646.3710  
Job Sheet 196530

Part Name: Doubler

| ENGINEERING CHANGE NOTICE NO. 03702                               |                         | SHEET 1 OF 2                                                                              |                 |
| REASON: ADDED ALTERNATE MATERIAL AND REVISED REFERENCE DIMENSIONS |                         | D-12-010                                                                                  |                 |

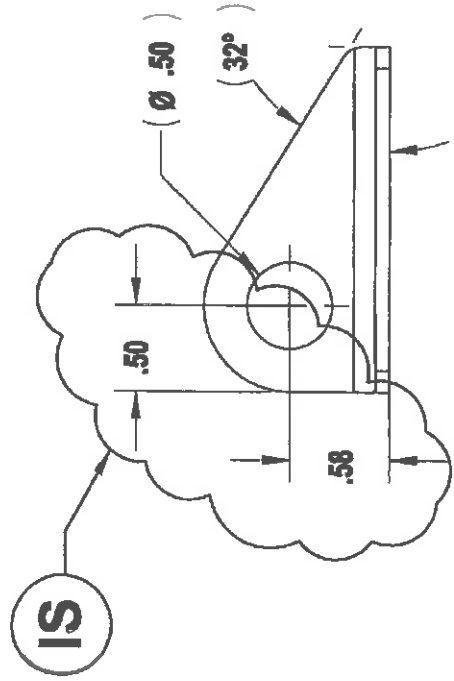
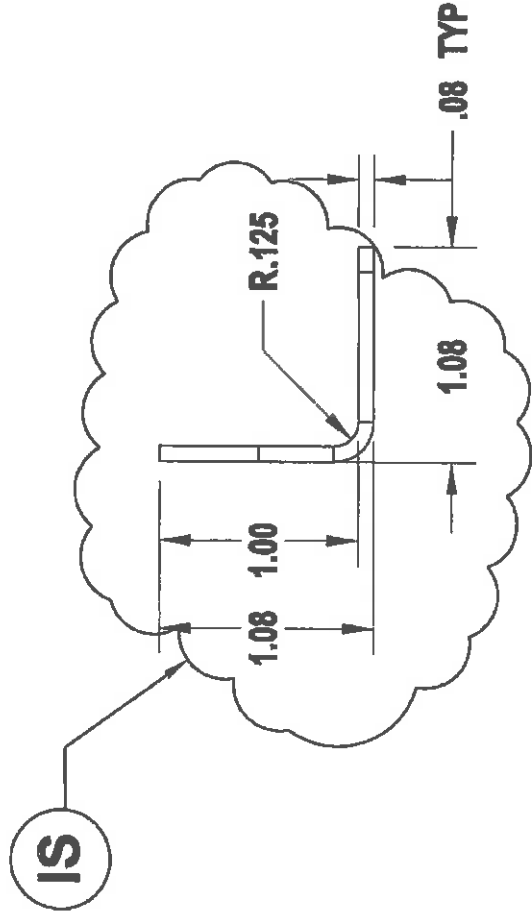
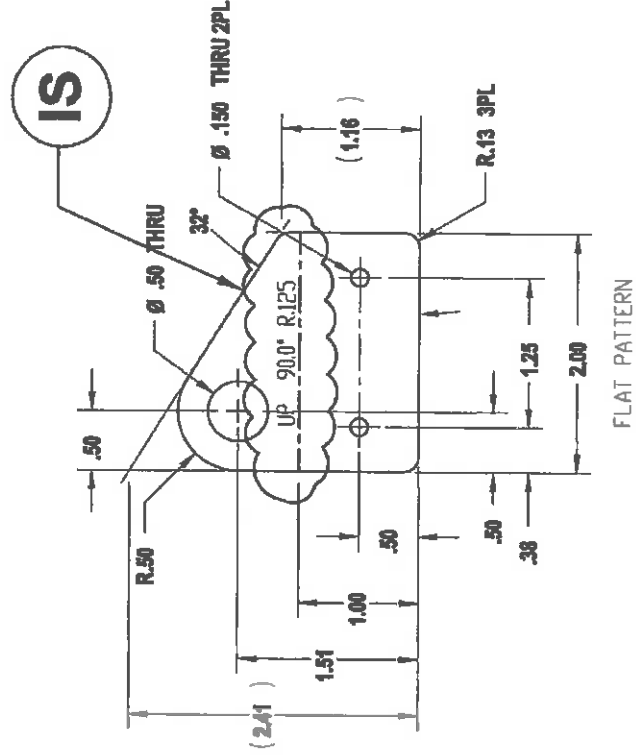
SHEET 1, ZONE A2 IS:

Δ PRIMARY MATERIAL: ALUMINUM 6061-T6 PER AMS-QQ-A-250/11  
ALTERNATE MATERIAL: SS 17-4 PH PER AMS 5604

SHEET 7, ZONE B1 IS:

SHEET 7, ZONE C4 IS:

SHEET 7, ZONE D1 IS:

SHEET 7, ZONE B7 IS:
